**Report: ISSUES
Function: Test, Adjust, & Balance
Date: 05/16/2023**

**PROJECT
05-15-23 BURLINGTON COAT FACTORY
#00315 HARVEY LA**

Ductwork1
05/17/2023

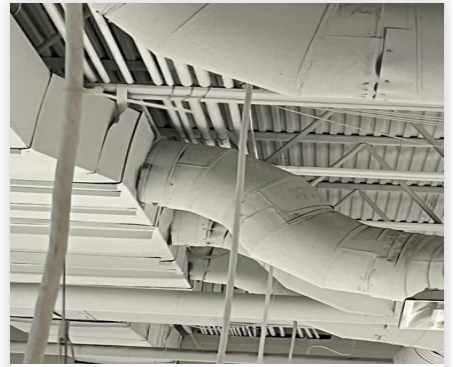
Issue Name : RTU4 ductwork leakage
Description : Ductwork for RTU4 is not sealed at the take off for many branches which is causing duct leakage and preventing unit from reaching design flow.
Created By : National TAB **Assigned To :** National TAB - Jacob Davidson
Status : Open
Originated Date : 05/17/2023 - Jacob Davidson - National TAB

RTU5
05/16/2023

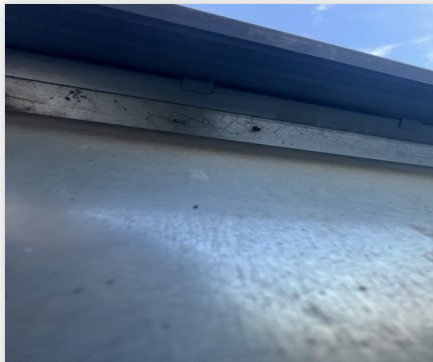
Issue Name : RTU5 off curb, Will cause low flow issues
Description : RTU5 is off curb to the point where there is major leakage from below the discharge compartment. This is going to prevent the unit from reaching the designed airflow.
Created By : National TAB **Assigned To :** National TAB - Jacob Davidson
Status : Open
Originated Date : 05/16/2023 - Jacob Davidson - National TAB
